**TECHNICAL REVIEW COMMITTEE  
PRELIMINARY COMMENTS AND/OR RECOMMENDED CONDITIONS**

**PROJECT CASE #:** C-247 **PARCEL PIN:** 5883-39-7339 & 5883-49-6486

**PROJECT TITLE/DESCRIPTION:** Harper Acres

**UDO:** RS-40 to RS-15-S

TABLE D103.4  
REQUIREMENTS FOR DEAD-END FIRE  
APPARATUS ACCESS ROADS

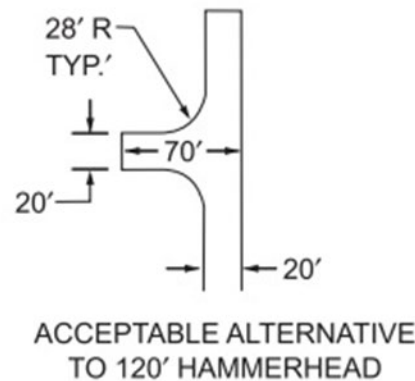
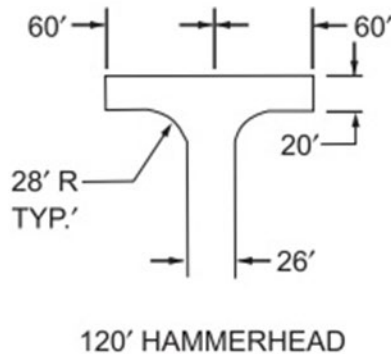
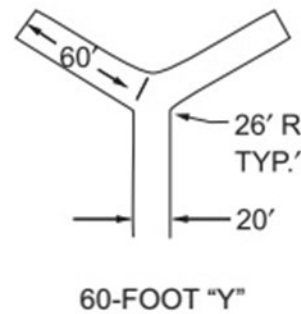
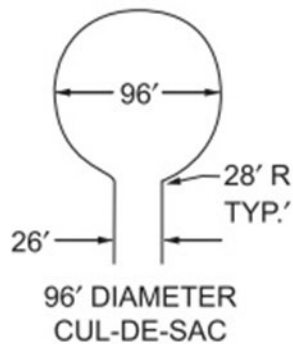
- Disapproved
- Cul-De-Sac not large enough
- No water source identified to meet the required fire flow.

- For fire apparatus access roads when the dead-end length of the required access road is more than 150 feet an approved turn around must be provided; **(503.2.5)(D103.4)**
- Turn around must meet the design criteria of the fire code. **(D103.4)**

14. Verify that all roadway design parameters meet the most current NCDOT Subdivision Roads Minimum Construction Standards.
15. Cul-de-sac shall be designed in conformance with Appendix D of the Fire Apparatus Turnarounds. A cul-de-sac diameter (pavement) of 96' is required.
